ADUR & WORTHING PLANNING SERVICES	
PLAN	AWDM/ 1822/18
DATE VALID	28 JAN 2019

AMENDMENT

PROPOSED SECTION.
REMOVAL OF ROOF AND NEW FIRST FLOOR EXTENSION. 80 GREENTREES CRESCENT, SOMPTING, LANCING, WEST SUSSEX. BN15 9SR.
DRAWING No: 201118/08 **Scale: 1:50.**

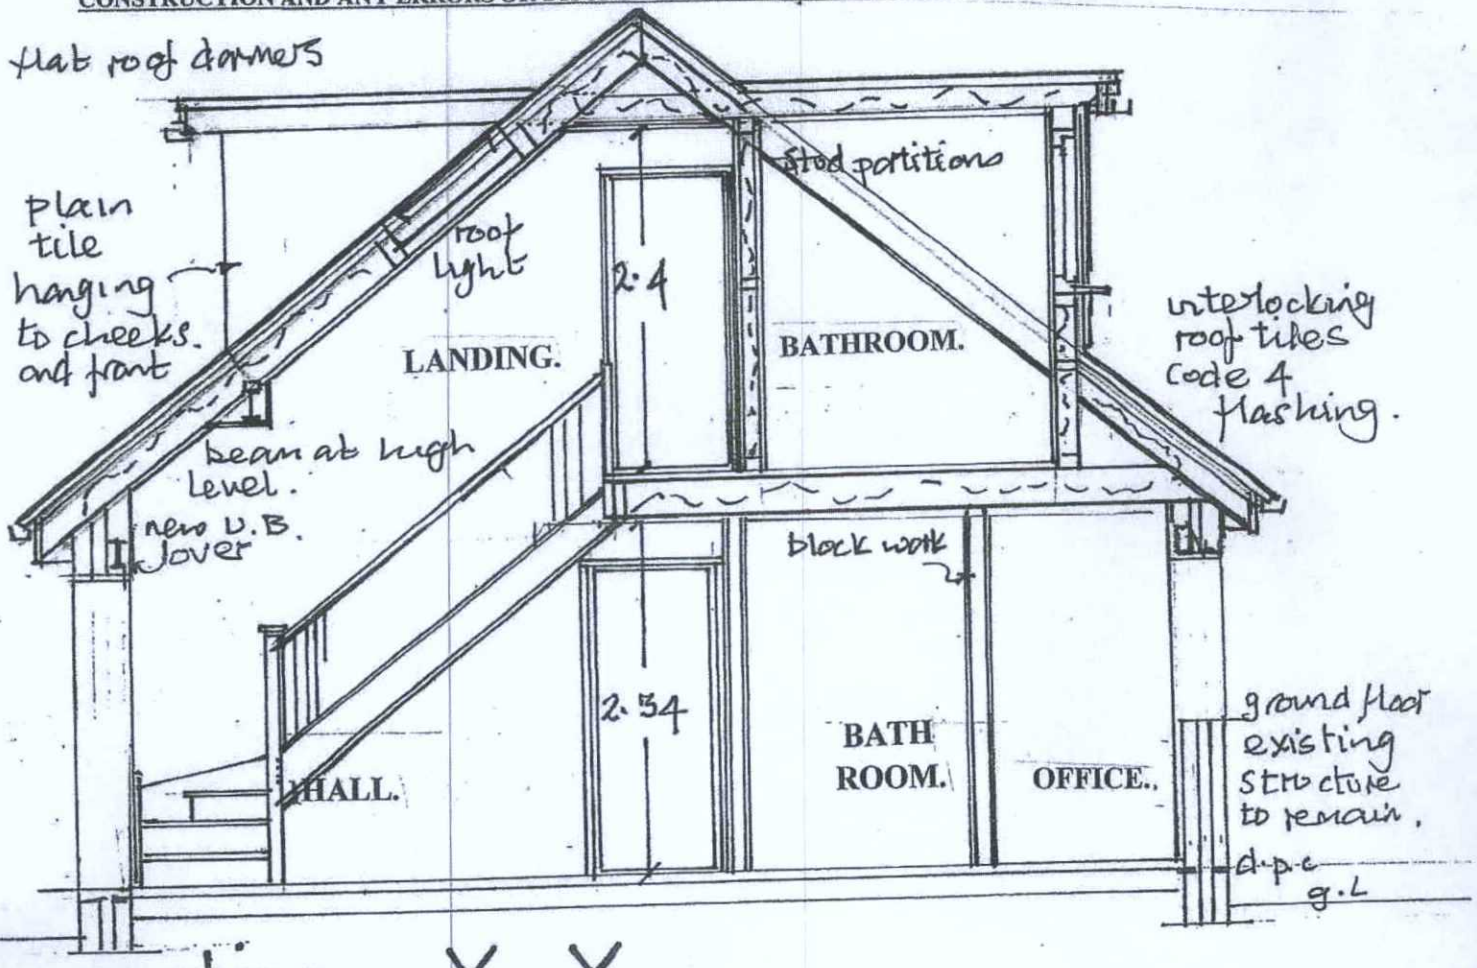
26-01-2019: 1) Roof pitch reduced to 37.5 degrees.
2) Flat roof dormers provided.
